PRELIMINARY SAFETY EVALUATION REPORT

TRANSNUCLEAR, INC.

STANDARDIZED NUHOMS® HORIZONTAL MODULAR STORAGE

AMENDMENT NO. 11

Figure 1.3 NUHOMS® OS197L TC System Decontamination Area Shielding

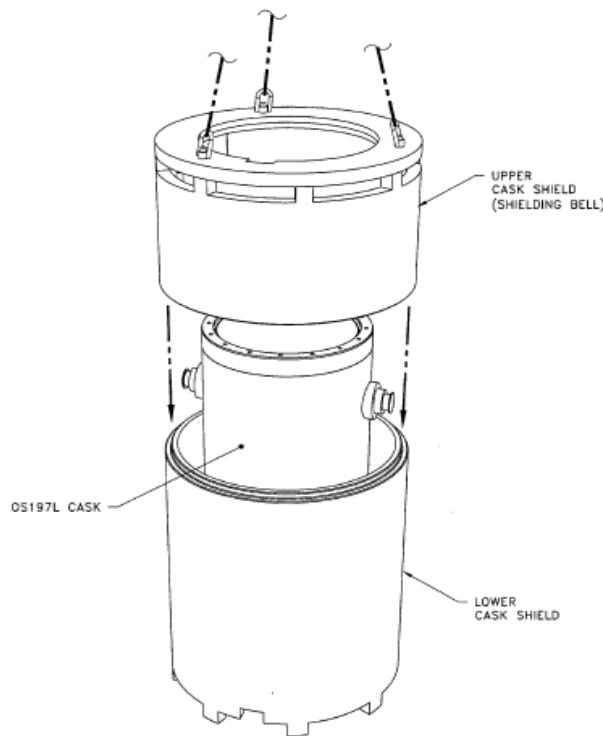
An evaluation was performed by the applicant to confirm that the radial gap between the OS197L TC and the inner diameter of the decontamination shield is sufficiently large, and that the top and bottom cut-out openings are of sufficient size as to not adversely affect the thermal performance of the OS197L TC. The decontamination area shielding is illustrated in SAR Figure W.1-2, and reproduced in Figure 1.3.

The applicant's evaluation is based on analysis of the free convection turbulent boundary layer development along the outer OS197L TC surface during vacuum drying and helium backfilling operations. The applicant states that the results of the evaluation confirm that the DSC shell-decontamination shield gap and the area of the inlet and outlet openings are adequate and, thus, the decontamination area shield does not adversely impact the cask boundary conditions assumed in the thermal analysis. No details of the analysis conducted by the applicant were provided in the SAR; however, in response to staff RAIs the applicant provided additional details for staff review.

Figure 5.1. FLUENT Model of NUHOMS® OS197L TC System with Supplemental Shielding

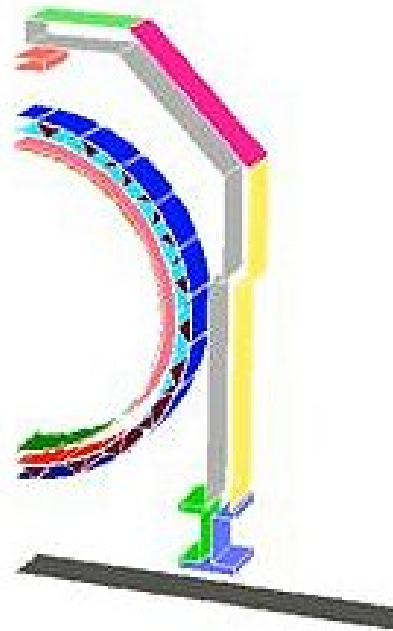
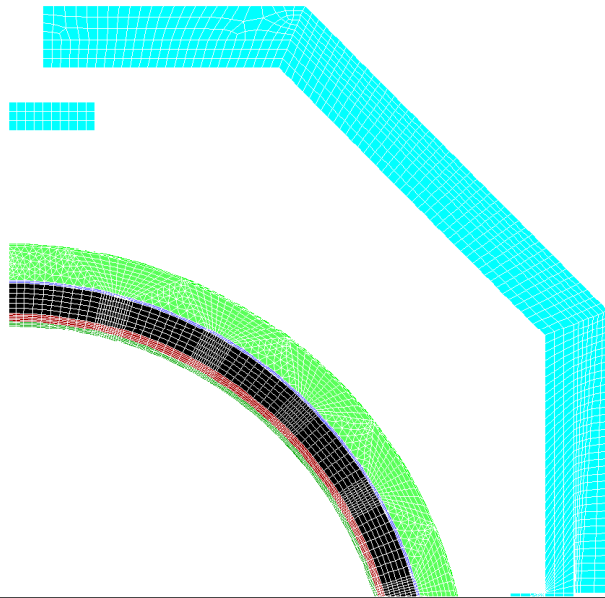
The OS197L transfer cask consists of a 2.68-inch thick steel cask body and a removable 3.5-inch thick liquid neutron shield assembly. The total water thickness of the neutron shield is 3 inches and the inner and outer stainless steel shells of the tank are 0.25 inches thick. The supplemental shielding consists of 3 sections. The lower section is a series of plates attached to the sides and ends of a typical transfer skid structure to provide the required shielding. Dual upper sections fit like clamshells over the cask and skid after the cask is placed on the transfer skid. The support legs on the skid provide an approximately 6.75-inch high clearance under the I-beams of the skid. Ambient air enters the enclosure through this clearance, flows around the

transfer cask, and exits via a 6-inch wide slot at the top, which extends 184 inches along the axial length of the supplemental shielding. (See Figures 5.1 and 5.2)

The staff's CFD analysis was performed for ambient conditions of 100°F and 24 kW of total decay heat, based on the decay heat evaluated by the applicant in earlier revisions of their SAR. The applicant later reduced the allowable decay heat load in the OS 197L TC to 13kW. A three-dimensional (3-D) FLUENT CFD model was prepared to represent a 12-inch section of the cask and the transfer skid. The representative transfer cask includes the DSC outer shell, the TC cask rails, the TC cask structural shell, and the liquid water neutron shield. Within the TC, the DSC sits on top of two cask rails, which are located 18.5° from vertical downward below the DSC. The thickness of the cask rails is assumed to be 0.12 inches. The air gap between the DSC shell and the transfer cask structural shell at the bottom closes from 0.405 inches to 0.105 inches. This air gap is also included in the analysis. A uniform 0.01-inch air gap between the cask structural shell and the neutron shield inner skin is modeled as well. The heat load of the fuel assemblies is applied as a uniform heat flux over the inner surface of the DSC shell. All material properties, including liquid water, are obtained from the applicant's SAR.

Three modes of heat transfer are included in the analysis including conduction, natural convection, and radiation. Radiation heat transfer is based on the Discrete Ordinates (DO) method. The staff performed the CFD analysis for normal conditions of transfer and obtained temperatures and a temperature distribution which are generally consistent with the trends found in the applicant's results. Therefore, based on the CFD analysis, the staff concludes that the applicant's approach to represent the heat transfer through the OS197L transfer cask is acceptable.

Figure 5-3 Peak Component Temperatures for 32PT DSC in OS197L TC: Off-Normal Conditions of Transfer (117°F ambient)

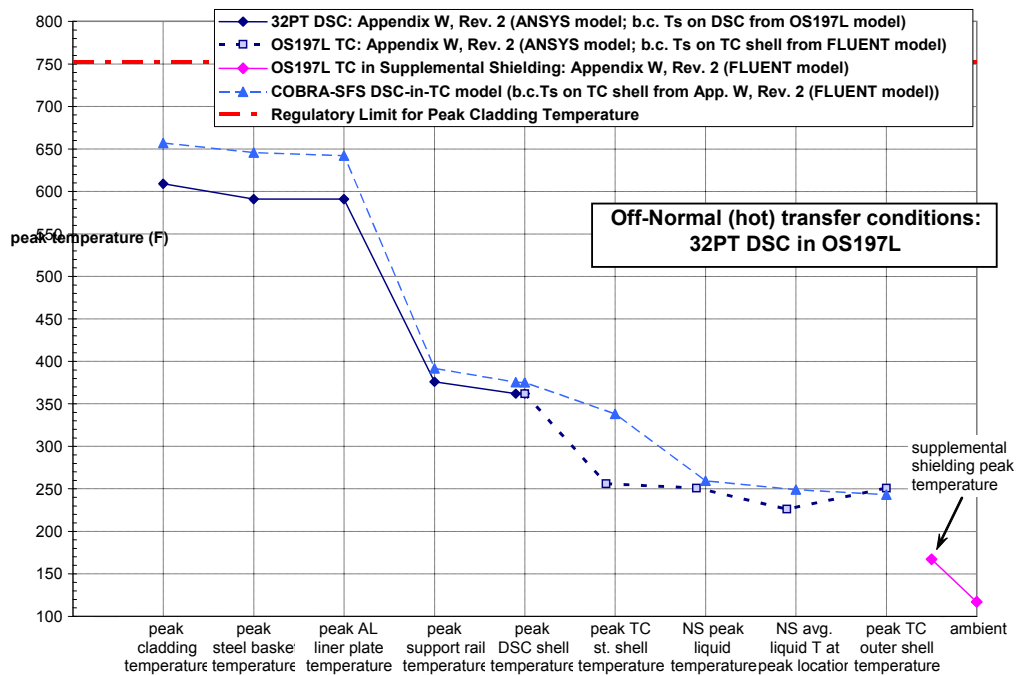
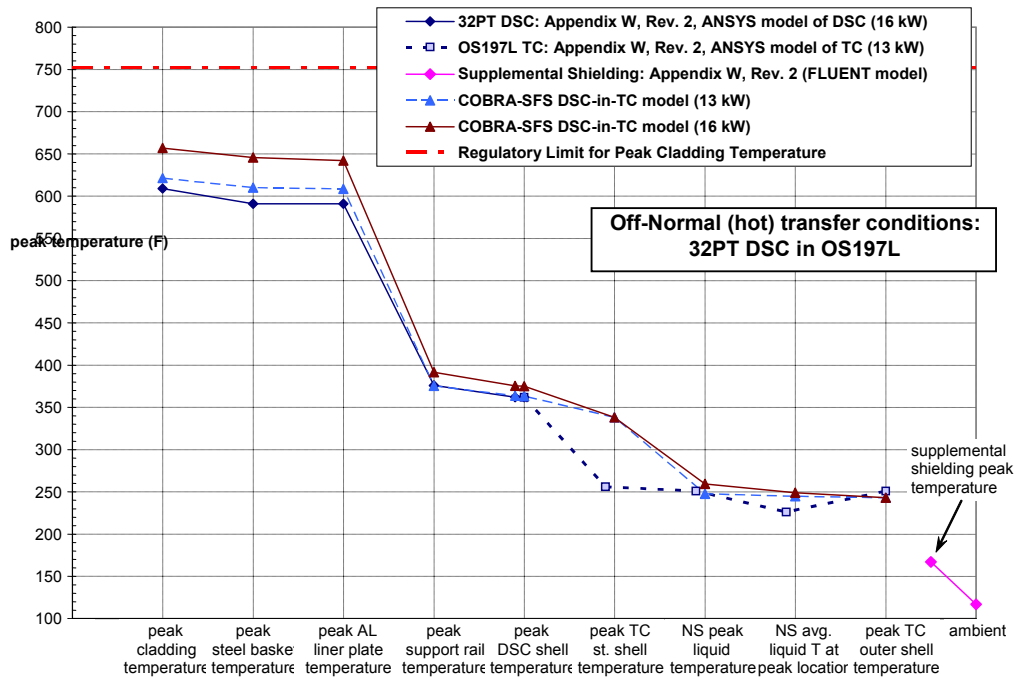
The temperature profile comparisons in Figures 5-3 and 5-4 show very good agreement in the results obtained for the OS197L transfer cask, and the peak DSC shell temperatures differ by

only about 16°F. The peak temperatures predicted for the aluminum support rails differ by approximately the same amount, with the confirmatory calculation results the more conservative of the two. (This is also in contrast to the results for the DSC model shown in Section 4.5.4, in which the SAR model results are more conservative than the confirmatory calculations.) Figure 5-5 shows this conclusively, with confirmatory calculation results with a COBRA-SFS model of the DSC only compared to Appendix W results for the detailed DSC model. In this comparison, both calculations use the same boundary temperatures on the DSC outer shell.

The plots in Figures 5-3, 5-4, and 5-5 show that the difference between the SAR Appendix W results and the confirmatory calculations are due two main causes. These are (1) differences in the detailed DSC model, in which the SAR model predicts a higher rate of heat transfer through the basket, and (2) decoupling of the DSC and TC heat transfer solution in the two-step approach used in the SAR methodology. The two effects are additive, in that both result in lower predicted peak component temperatures within the DSC. The differences in the detailed DSC model result in a higher predicted rate of heat removal from the basket, and the decoupling of the DSC and TC results in lower boundary temperatures on the DSC shell.

As indicated in Figure 5.3 above, the non-conservative results obtained with the SAR model compared to the confirmatory calculations can be further illustrated by comparison with results reported in Appendix M, for the 32PT within the original (heavier) OS197. Figure 5-6 shows the results for the 32PT using the DSC shell temperatures reported in Appendix M. As with the comparison for Appendix W (shown in Figure 5-5), the confirmatory calculation results are more conservative than those obtained with the ANSYS model documented in Appendix M. The peak cladding temperature predicted in the confirmatory calculations is approximately 24°F higher than the value obtained with the ANSYS model and reported in the SAR. However, for the 32PT DSC within the OS197, which does not require supplemental shielding, the peak cladding temperature obtained in the confirmatory calculations is 13°F below the temperature limit, and therefore the results obtained with the methodology documented in Appendix M were deemed acceptable.

For application to the analysis of the 32PT within the OS197L as presented in Appendix W, however, the non-conservatism of the methodology from Appendix M with respect to the confirmatory calculations is unacceptable, because the peak cladding temperatures are predicted to be much closer to the limit. The results obtained in the confirmatory calculations

predict peak cladding temperatures that are above the regulatory limit for normal and off-normal

Figure 5-5 Peak Component Temperatures for 32PT DSC with DSC shell boundary temperatures from OS197L TC model in Appendix W: Off-Normal Conditions (117°F ambient)

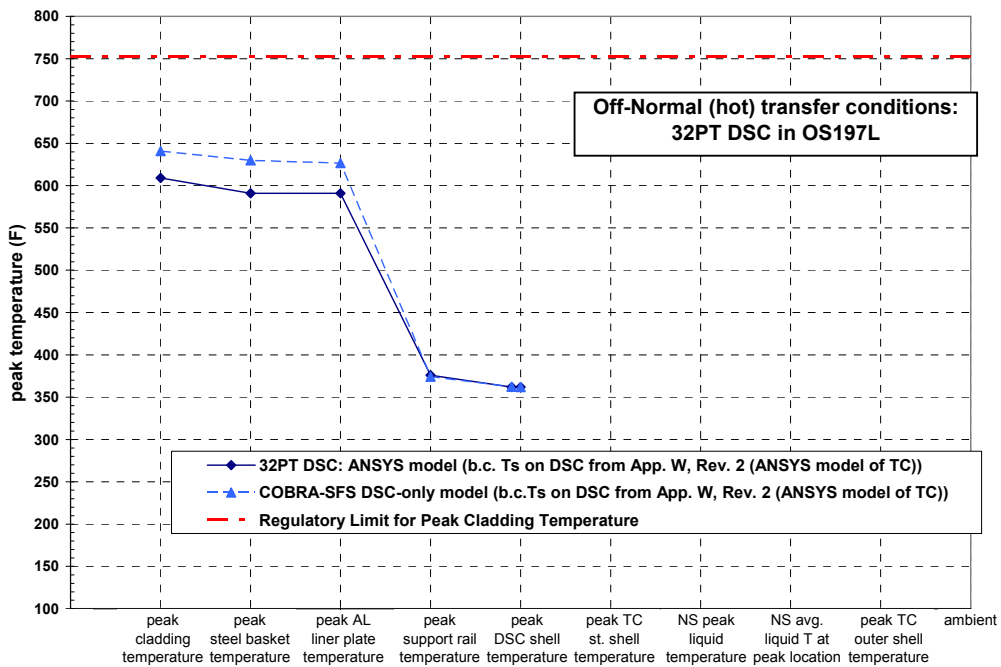
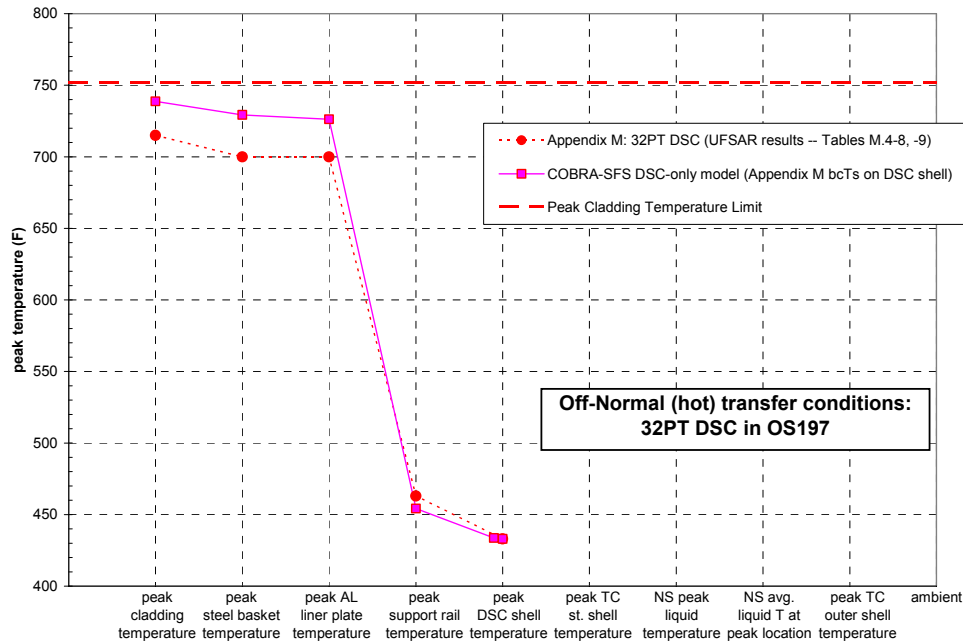
conditions of transport for a heat load of 24 kW. These results were obtained using the boundary temperatures calculated by the applicant, using their FLUENT model of the TC within the supplemental shielding.

Figure 5-7 Peak Component Temperatures for 32PT DSC within OS197 TC, with and without supplemental shielding: Off-Normal Conditions (117°F ambient)

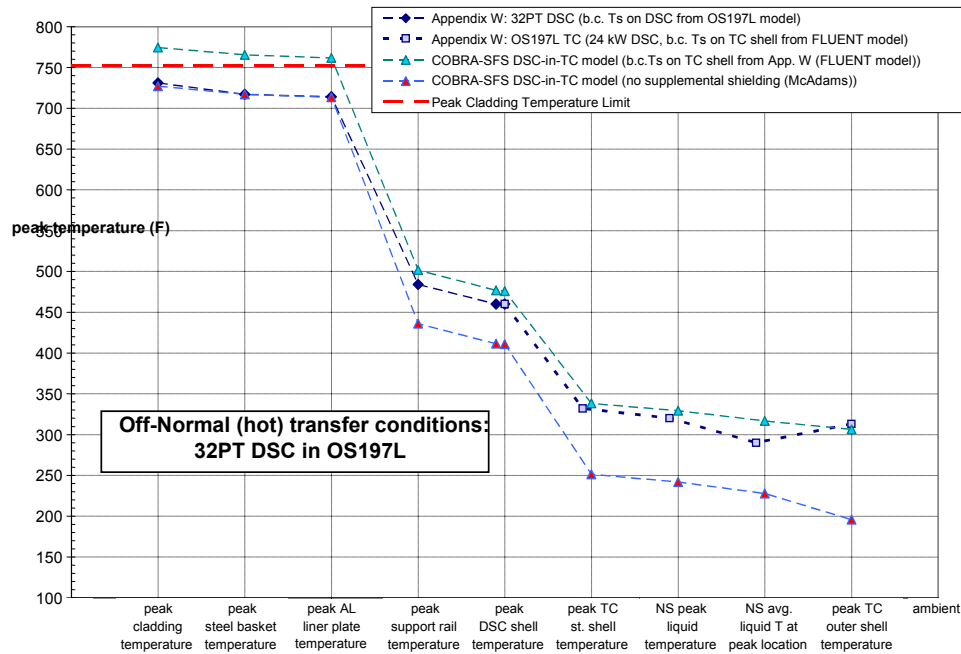
The results obtained for this case are compared to the SAR Appendix W results in Figure 5-7. The confirmatory calculations indicate that without the supplemental shielding, the peak temperature on the OS197L external surface would be more than 100°F lower than the value predicted in the SAR Appendix W with the FLUENT model. As a result, the peak cladding temperature in the confirmatory calculation is only about 727°F, which is 4°F below the value predicted with the SAR methodology *with* the supplemental shielding in place. This further illustrates the non-conservatism of the detailed DSC model in the SAR.

During the course of the staff's review, the applicant chose to revise the maximum decay heat loading for the 32PT DSC downward from 24 kW to 13 kW. Additional calculations were submitted showing the results obtained with the FLUENT model of the OS197L within the

supplemental shielding, with a 13 kW decay heat load represented as a uniform surface heat flux on the TC outer shell. Figure 5-8 shows the effect on the predicted TC surface temperatures, in which the reduced heat load results in the reduction of the TC surface temperature by approximately 60 °F (33.3°C).
